BOARD OF ZONING APPEALS DIVISION I

Case Number: 2024-DV1-027

Property Address: 5101 East Thompson Road (approximate address)

Request: Variance of Development Standards of the Consolidated Zoning and Subdivision Ordinance to provide for the location of two drive-throughs and stacking spaces within the front yard of Thompson Road (not permitted) and without required bypass aisles, deficient compliance with various landscaping standards, and 64 parking spaces accessory to a restaurant use (maximum 25 spaces permitted for proposed square footage).

2024DV1027 ; Lot 1 Detail + Landscaping

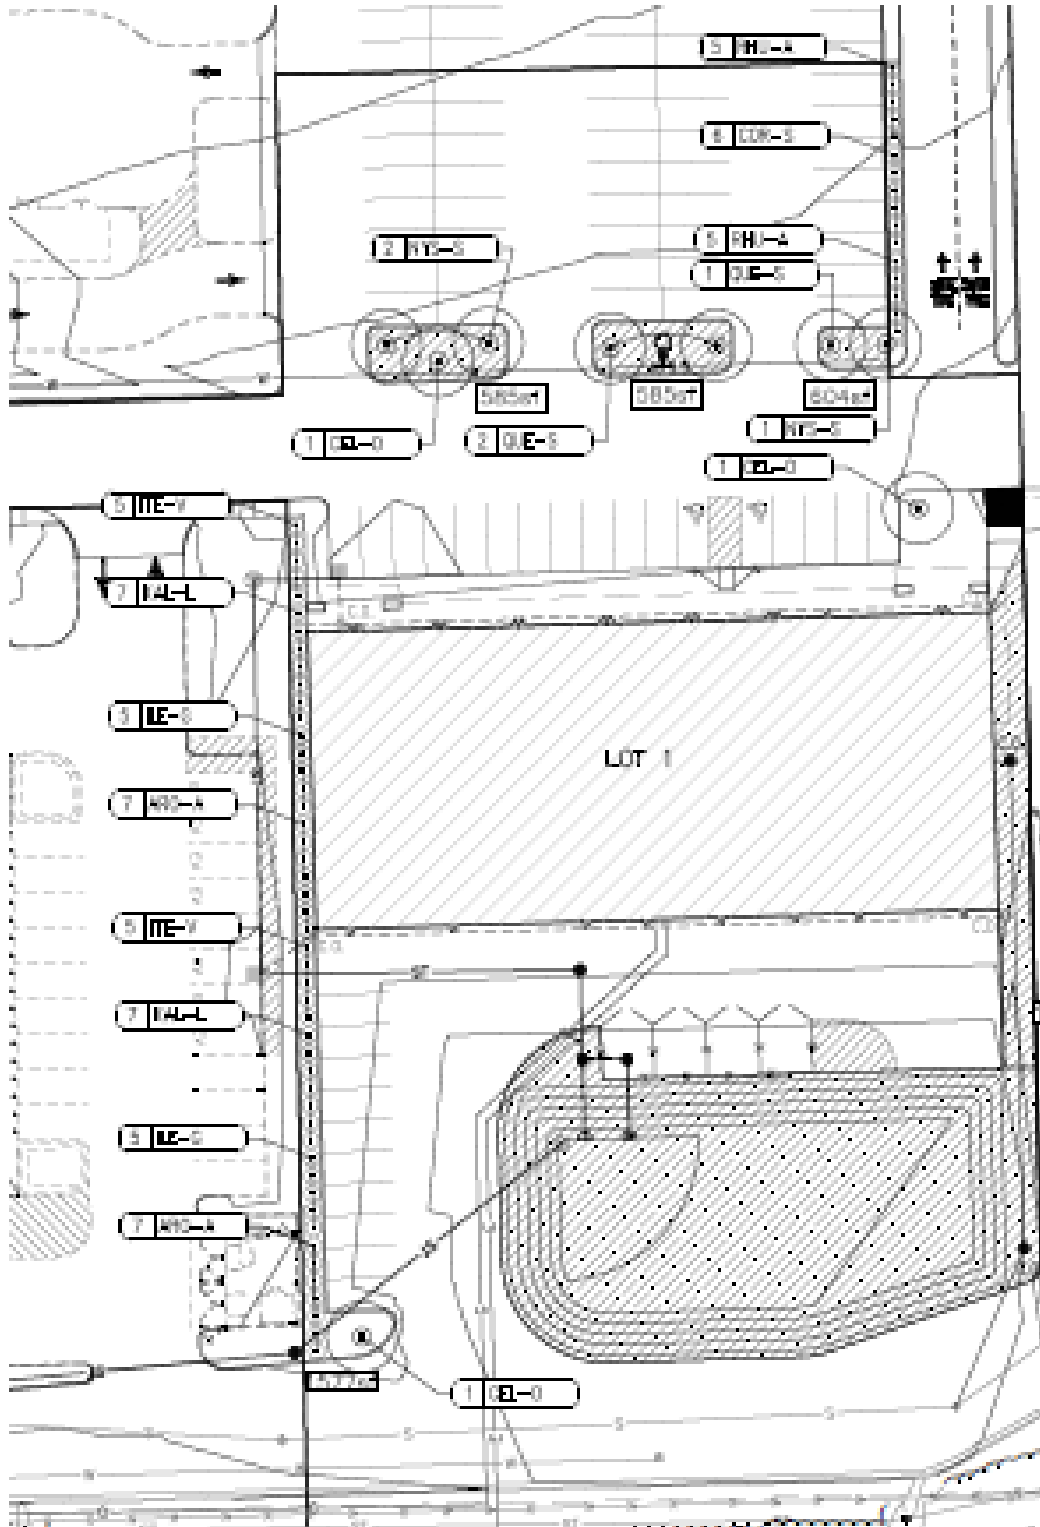
- Staff was not provided with details on the specific tenants utilizing the proposed Lot 1 building or elevation renderings for any of the proposed structures, and any potential non-conformities with the amounts of parking, transparency, or internal connectivity of pedestrian walkways would not be legalized by approval of this variance.

- The landscape plans provided also show plantings less than 3 feet from the property line to the east and no plantings along the approximately 40-foot transitional yard that Lot 1 has along Emerson to the west. Given that the property to the east is a part of the same large commercial center and that the small yard to the west would be comprised of a private access drive with adequate transitional yard landscaping along Lot 3's boundary to the north, staff feels these are both minor deviations from ordinance requirements.

2024DV1027 ; Lot 2 Detail + Landscaping

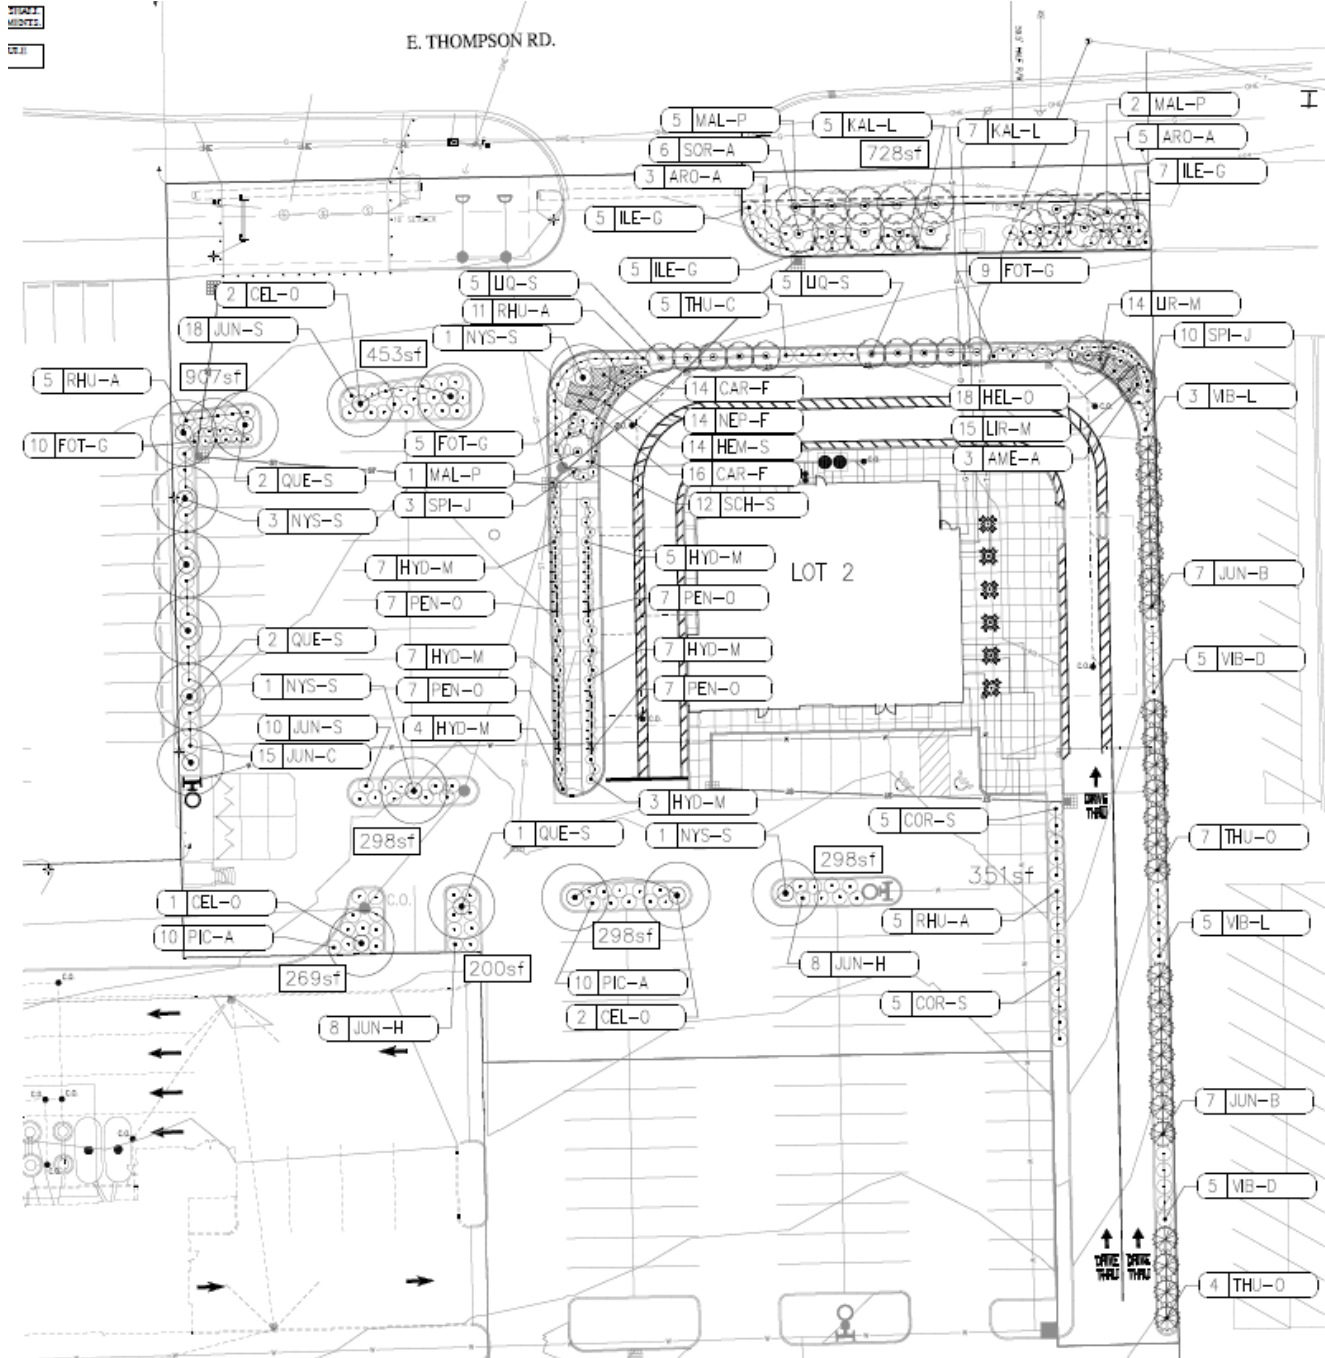
- The proposed layout of the drive-through units servicing Lots 2 and 3 would also require variance: neither appears to have an exclusive bypass aisle to allow for vehicles to exit the unit, and the Lot 2 layout shows stacking spaces within the front yard along Thompson Road (the definition of 'service unit' for auto washes in 744-406 means that the car wash spaces in the front yard of Emerson would not be subject to the need for variance).

- Regulations on stacking spaces and drive-through layouts exist to, among other reasons, ensure optimal circulation and egress for motorists while allowing for vibrant and pedestrian-oriented storefronts by reducing the placement of vehicles within front yards. Legalization of a drive-thru without the ability for bypass may create hardship for motorist experiencing personal or vehicular emergencies, and it is unclear why the proposed deviation would create superior circulation for the site. Staff notes that other nearby fast-food restaurants (Dairy Queen to the east and both Wendy's and Hardee's to the north) appear to meet the standards of the ordinance without issue, and adequate evidence to establish practical difficulty has not been provided to justify these deviations. Staff would recommend denial of this variance request.
